A Review of Key Environmental Considerations Related to Denison Mines' Wheeler River Uranium Project

MiningWatch Canada October 24, 2025

Figure 1. Surface water bodies near the Wheeler River Project site

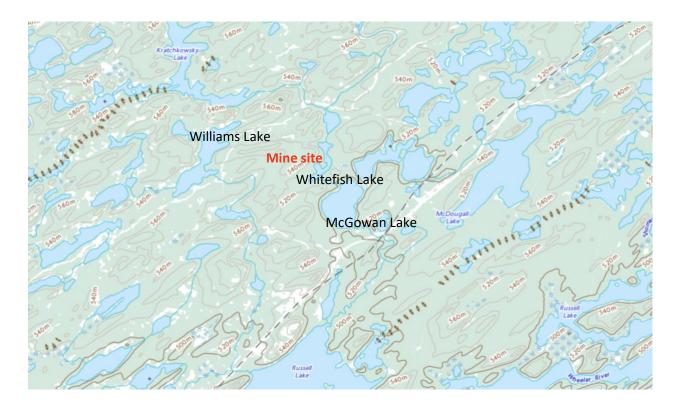
The Wheeler River Project represents a first-ever attempt to use acid ISL technology in a portion of the Canadian Shield with complex hydrology and extensive surface water bodies. Figure 1 shows that lakes occupy a high proportion of the landscape around the proposed mine site.

Contaminated groundwater would primarily enter Whitefish Lake, flow into McGowan Lake, and into Russell Lake, a widening of the Wheeler River. The Wheeler River, in turn, enters the Geikie River. It flows into Wollaston Lake. Wollaston Lake is a bifurcated lake that drains in two directions: west to Lake Athabasca and the Mackenzie Basin via the Fond du Lac River; and east to Reindeer Lake and the Churchill Basin via the Cochrane River.

First Nations' concerns about significant adverse environmental impacts on surface water bodies are justified. Power outages could compromise maintenance of the freeze wall during operational and decommissioning phases of the Project. Past experience with acid ISL mining suggests poor prospects for groundwater remediation. Faults in the Athabasca Basin sandstone provide preferential pathways for groundwater migration to surface water bodies. Hydrologic studies show upward groundwater migration to Whitefish Lake.
